CITY OF AUSTIN
Board of Adjustment/Sign Review Board
Decision Sheet

CASE NUMBER: C15-2013-0066

ADDRESS: 303 BRENTWOOD ST

COMMENTS TO THE CITY OF AUSTIN BOARD OF ADJUSTMENT REGARDING
CASE NUMBER C15-2013-0066 (303 BRENTWOOD STREET 78752)

1 ARCHITECTURAL SITE PLAN - PROPOSED CONSTRUCTION
1" = 20' 0"

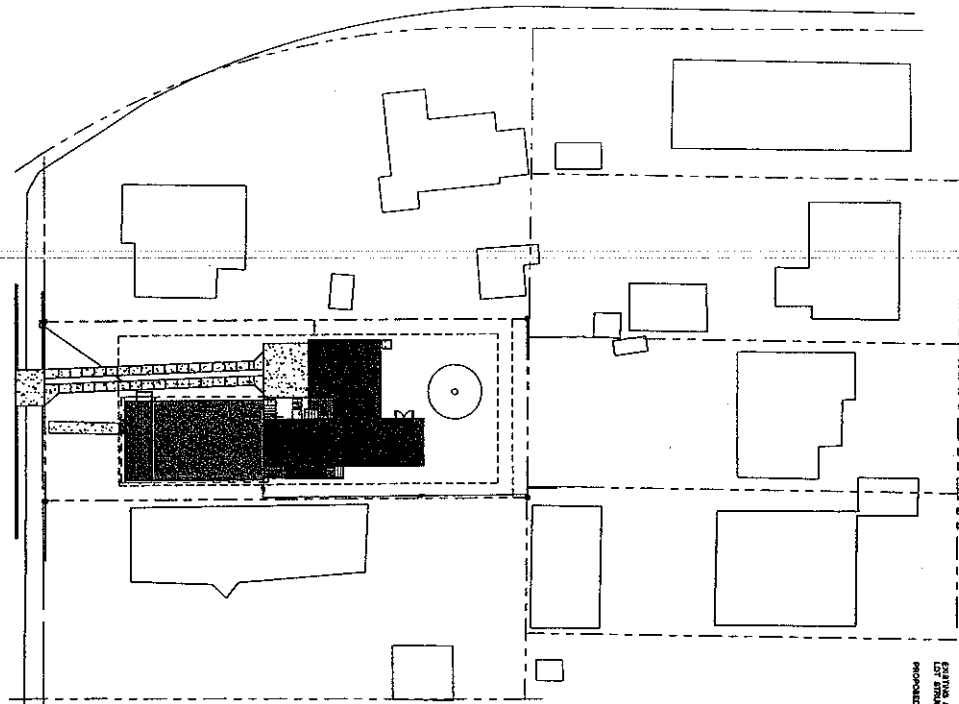
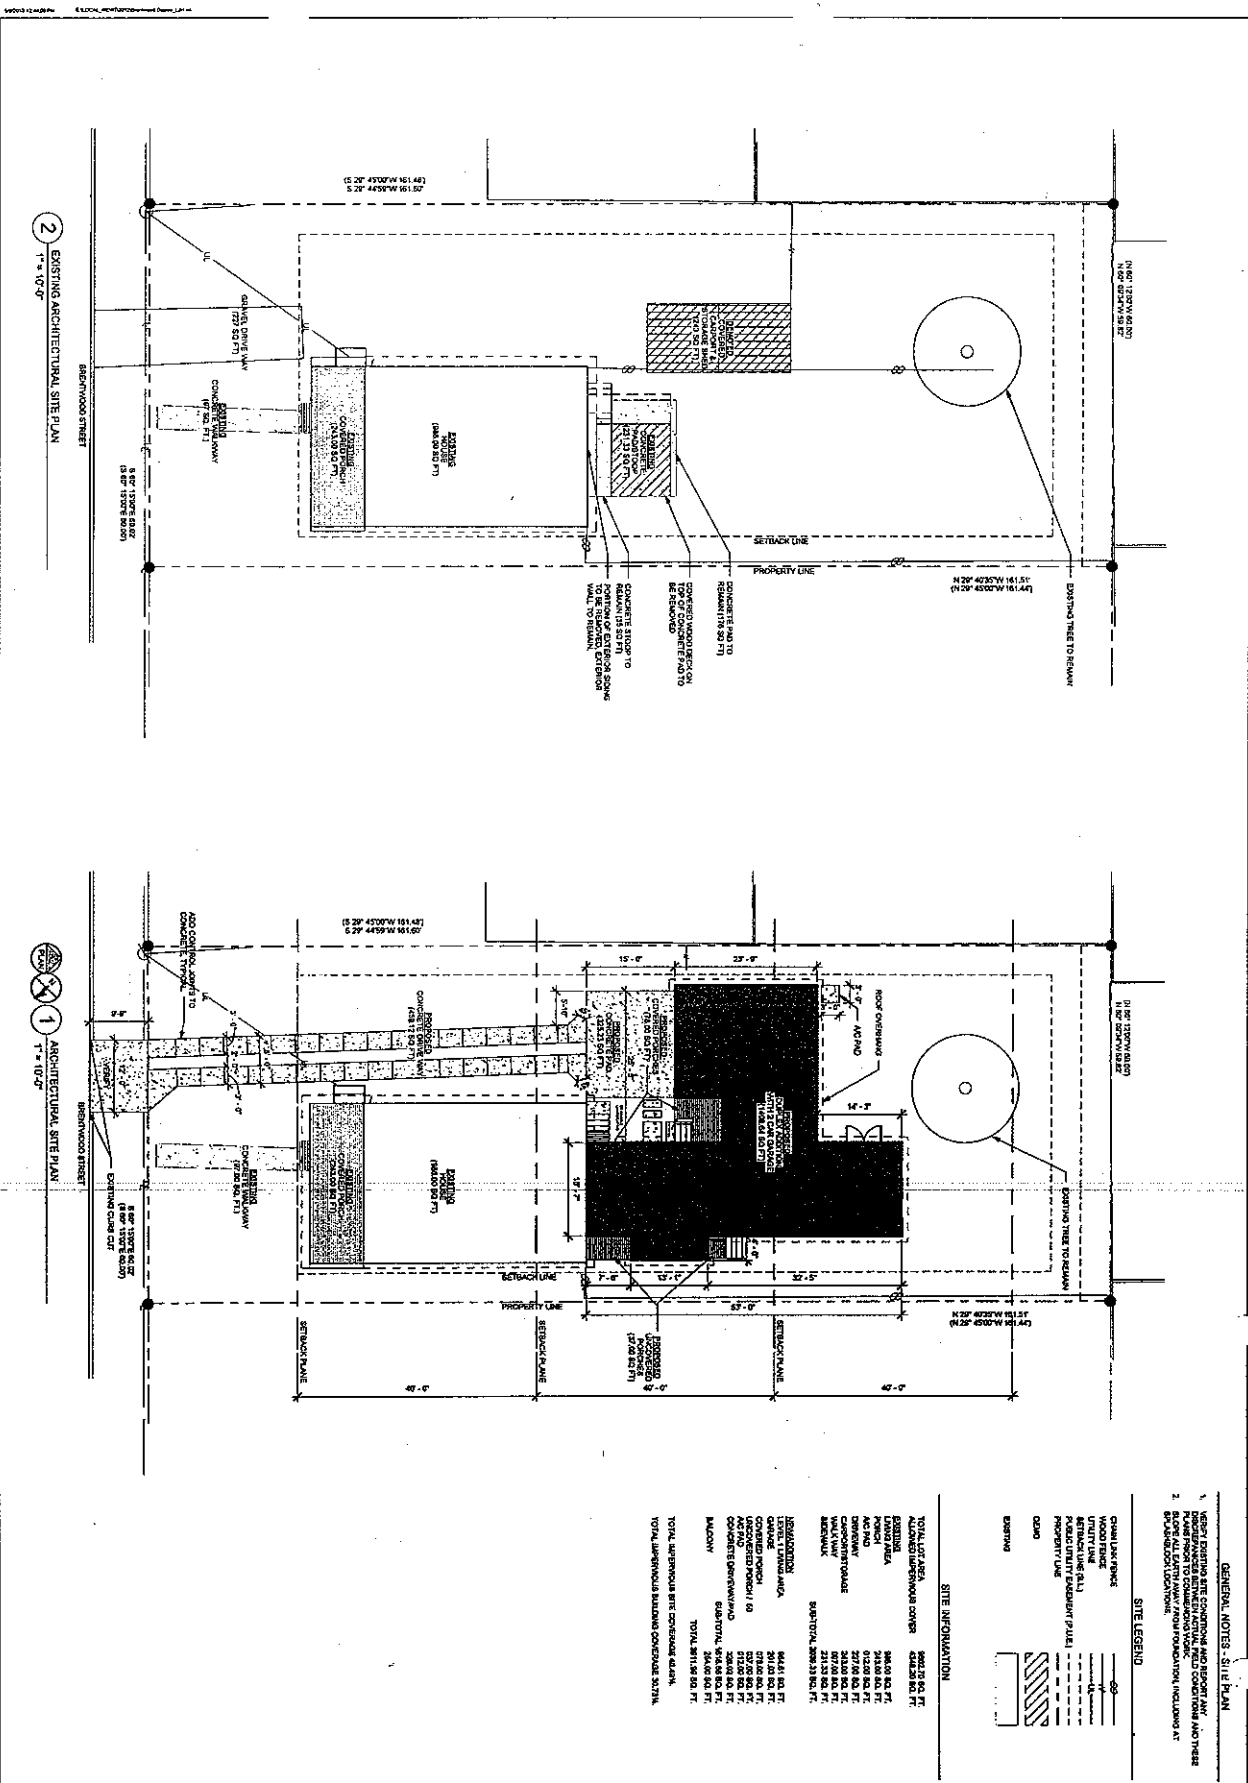
1. From the plans provided it is not clear how many bedrooms are proposed, i.e. how many occupants will likely be living there. Is it anticipated that there will be two families there or will it more likely be six or more unrelated individuals? This is especially important because of the parking arrangement provided. Although the long driveway leading to the proposed garage will accommodate several cars, parking a single car in the driveway will prevent other cars from moving. The likely result of this is that many resident's cars will be parked on the street in front of this property and the neighboring properties. The site plan seems to indicate that more convenient parking could be provided on either side of the proposed driveway.

4. The proposed site plan shows an air conditioning pad to the east side of the property. Will this be required to be located as indicated, or might it actually end up a few feet from our property? Also, the existing structure does not have central air conditioning. If this changes, where will the condensing unit be located? This is important to us because, again, our existing structure is so close and because the main living room opens to a courtyard enclosed by the boundary-line fence.

EXTERIOR ELEVATIONS
A201

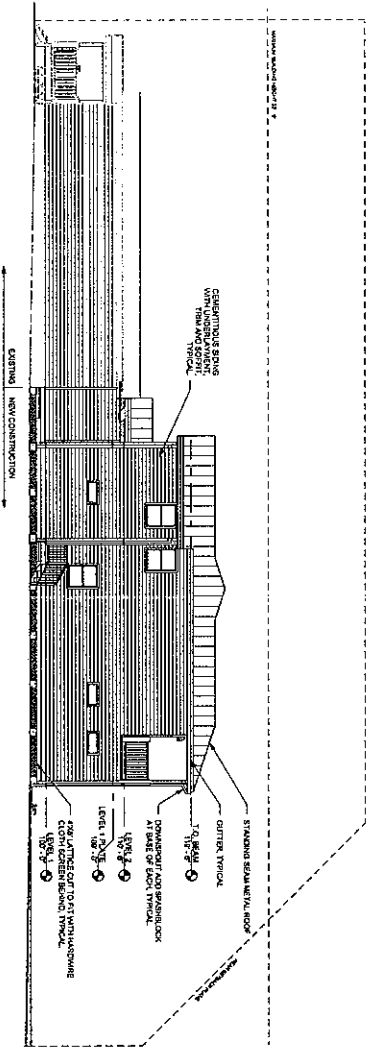
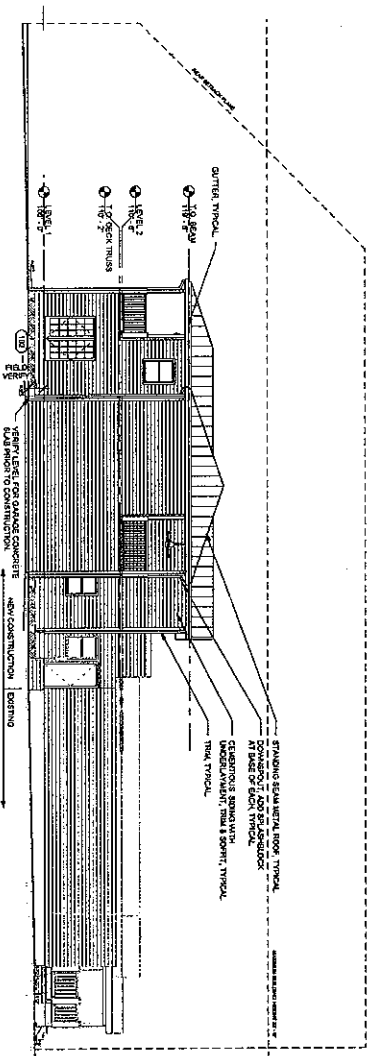
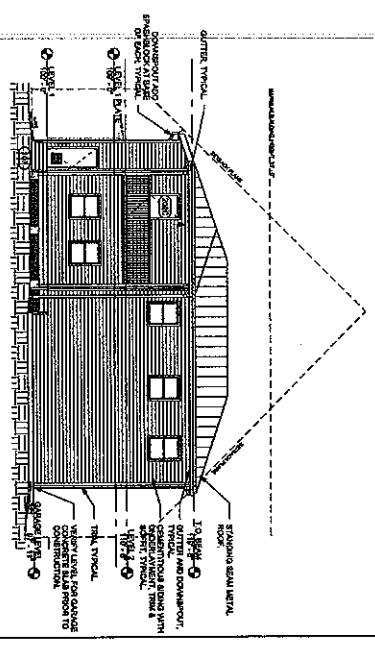
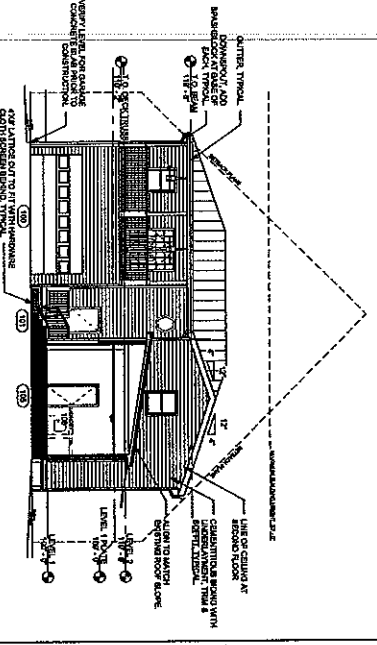
3. The existing houses in the neighborhood are almost entirely single-story with eight-foot wall construction. The proposed addition would be two-story with ten-foot walls on each floor. The plans seem to indicate that this will (barely) comply with the maximum building envelope mandated by the "McMansion ordinance". However, this will definitely result in a new structure which will loom over our existing single-story house, especially since both structures are located on or near the five foot side setback line. If the proposed structure were to have eight or even nine-foot walls, the looming effect would be greatly reduced. Is it possible to require this as part of approving this variance?
